Subject: Information Report, NHTSA No. 98V-22~~1~~³

Section 573.5 Defect Information Report

Subject: XC Side Radiator Hydraulic System
FL243AD U.S.
FC243AD Canada

Subject: XC Side Radiator Hydraulic System

Fig. 1, Installation of Hydraulic System Accumulator

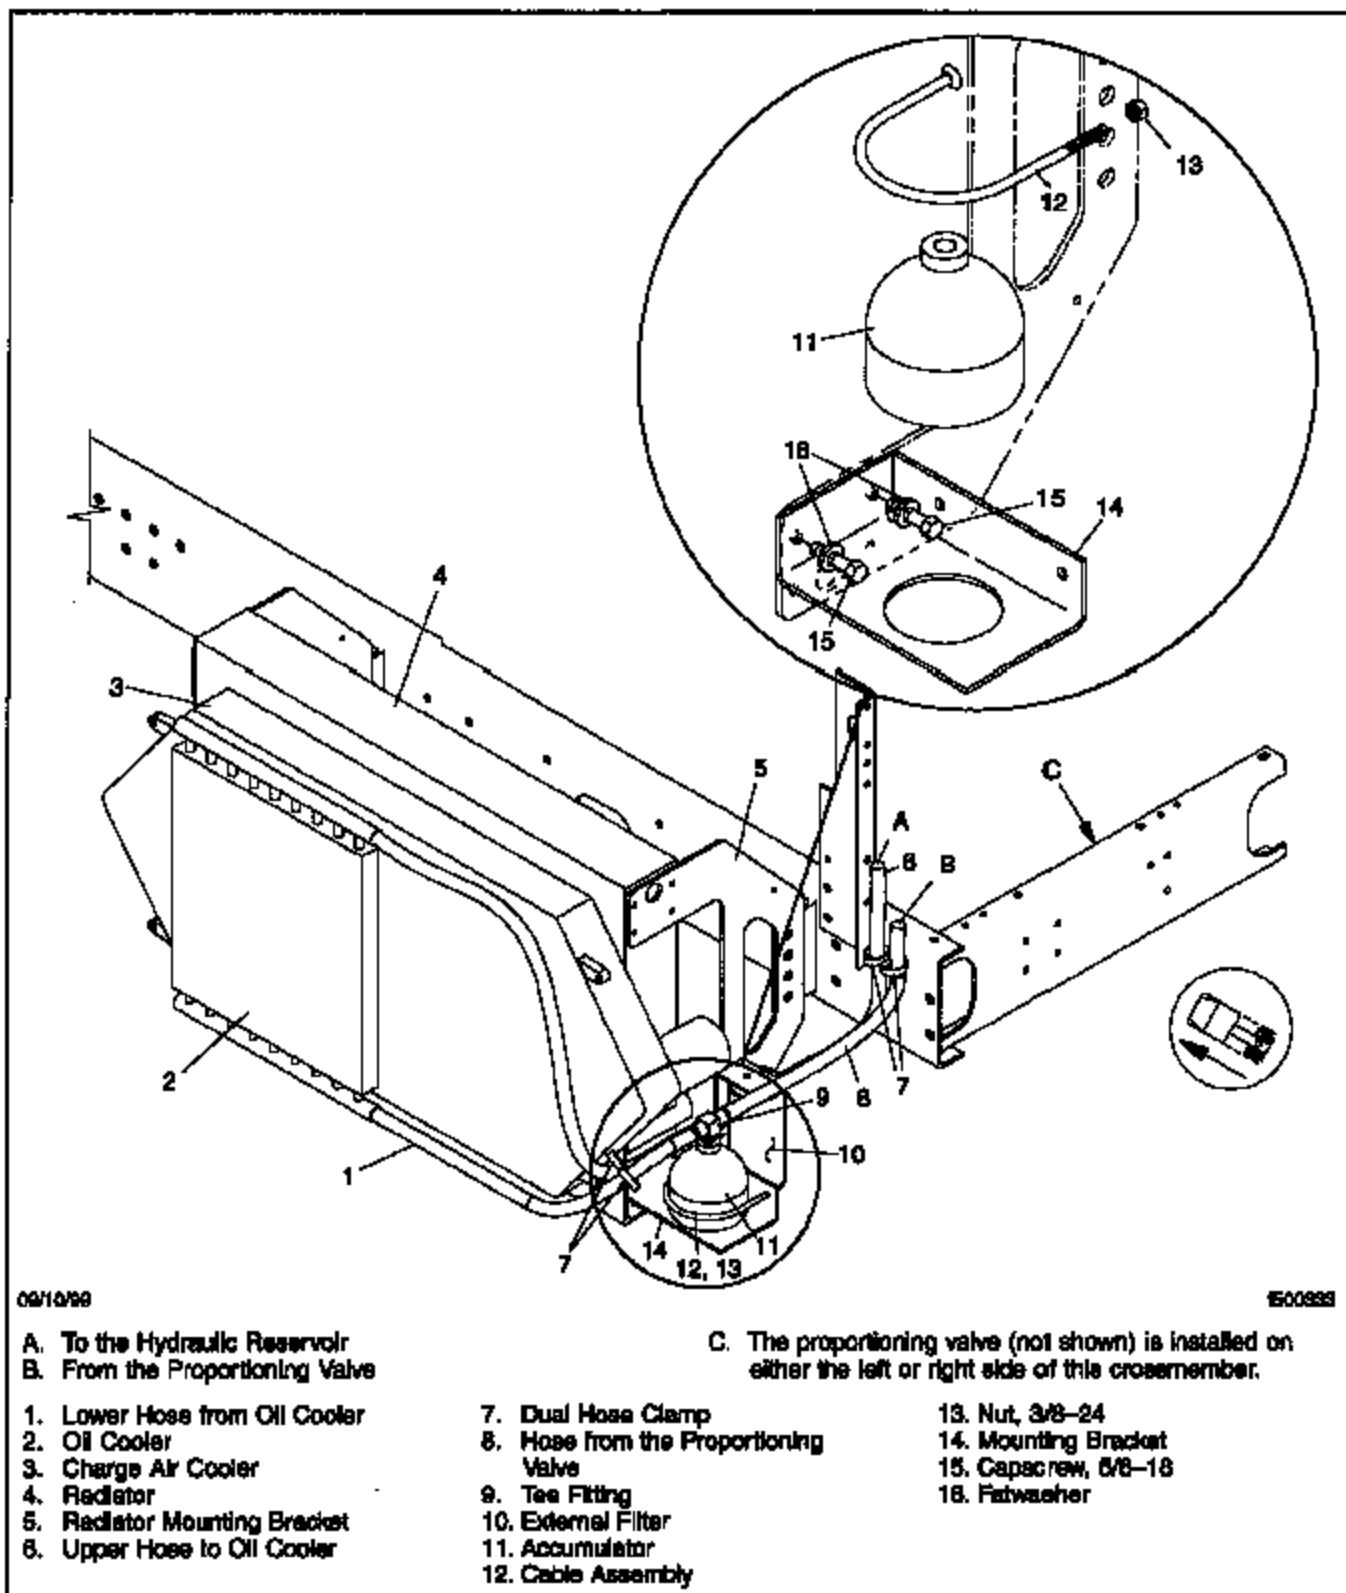
The filter gasket for the power steering hydraulic fluid may blow out due to pressure spikes in the system. This can result in a loss of power steering fluid and an eventual loss of power assist to the steering if the leak is undetected. The vehicle will retain mechanical steering capability.

The modification consists of adding an accumulator to the hydraulic system on all vehicles. The external filter should also be removed from vehicles equipped with a metal hydraulic fluid reservoir.

4. Put a clean container under the power steering reservoir and disconnect the supply hose from the reservoir to drain the system.
5. Disconnect and remove the hose connecting the proportioning valve to the lower end of the oil cooler. See Fig. 1.

8. Install the Tee-fitting onto the accumulator and tighten 20 lbf-ft (27 N-m).
9. Seat the accumulator onto the mounting bracket. See Fig. 1.
10. Using the cable assembly and the 3/8-24 nut, secure the accumulator to the bracket. See Fig. 1. Tighten the nut 30 lbf-ft (40 N-m).

11. Connect the new hoses from the kit to the tee on the accumulator. Tighten the fittings 20 lbf-ft (27 N-m).
12. Connect one hose to the bottom of the oil cooler. Then, connect the other hose to the proportioning valve. Tighten the fittings 20 lbf-ft (27 N-m).

13. Using two dual hose clamps, secure the hoses together. See Fig. 1.
14. Check the type of power steering reservoir.

If equipped with a 12-quart metal reservoir, check for an external filter near the oil cooler, in the hydraulic hose running from the top of the oil cooler to the reservoir. See Fig. 1.

If the filter is present, remove it and connect the hose ends using a union fitting from the kit. Tighten the fittings 20 lbf-ft (27 N-m).

IMPORTANT: Remove the external filter *only* if equipped with a metal reservoir. If the vehicle is equipped with a plastic reservoir, do not remove the external filter; leave it in place.

Fig. 1, Installation of Hydraulic System Accumulator

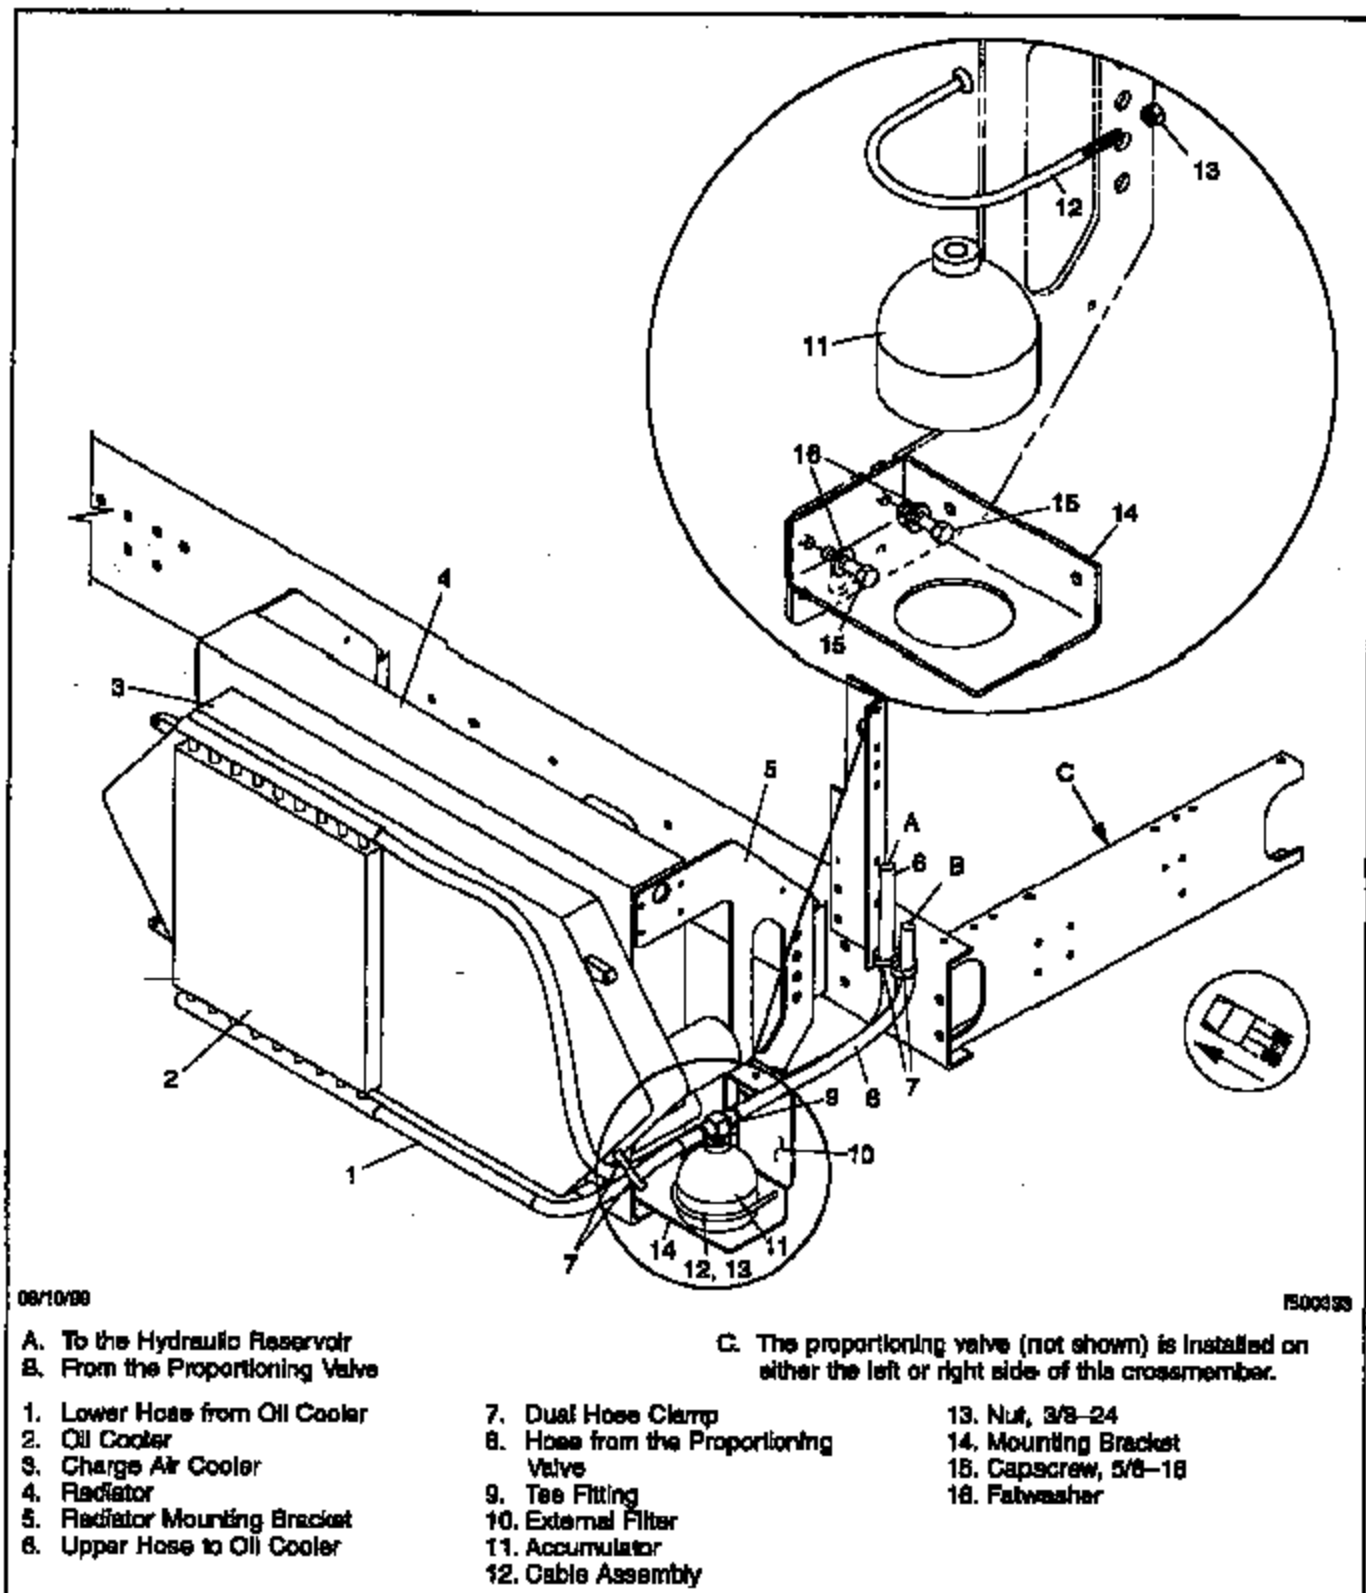
The filter gasket for the power steering hydraulic fluid may blow out due to pressure spikes in the system. This can result in a loss of power steering fluid and an eventual loss of power assist to the steering if the leak is undetected. The vehicle will retain mechanical steering capability.

The modification consists of adding an accumulator to the hydraulic system on all vehicles. The external filter should also be removed from vehicles equipped with a metal hydraulic fluid reservoir.

4. Put a clean container under the power steering reservoir and disconnect the supply hose from the reservoir to drain the system.
5. Disconnect and remove the hose connecting the proportioning valve to the lower end of the oil cooler. See Fig. 1.

8. Install the Tee-fitting onto the accumulator and tighten 20 lbf-ft (27 N-m).
9. Seat the accumulator onto the mounting bracket. See Fig. 1.
10. Using the cable assembly and the 3/8-24 nut, secure the accumulator to the bracket. See Fig. 1. Tighten the nut 30 lbf-ft (40 N-m).

11. Connect the new hoses from the kit to the tee on the accumulator. Tighten the fittings 20 lbf-ft (27 N-m).
12. Connect one hose to the bottom of the oil cooler. Then, connect the other hose to the proportioning valve. Tighten the fittings 20 lbf-ft (27 N-m).

13. Using two dual hose clamps, secure the hoses together. See Fig. 1.
14. Check the type of power steering reservoir.

If equipped with a 12-quart metal reservoir, check for an external filter near the oil cooler, in the hydraulic hose running from the top of the oil cooler to the reservoir. See Fig. 1.

If the filter is present, remove it and connect the hose ends using a union fitting from the kit. Tighten the fittings 20 lbf-ft (27 N-m).

IMPORTANT: Remove the external filter only if equipped with a metal reservoir. If the vehicle is equipped with a plastic reservoir, do not remove the external filter; leave it in place.
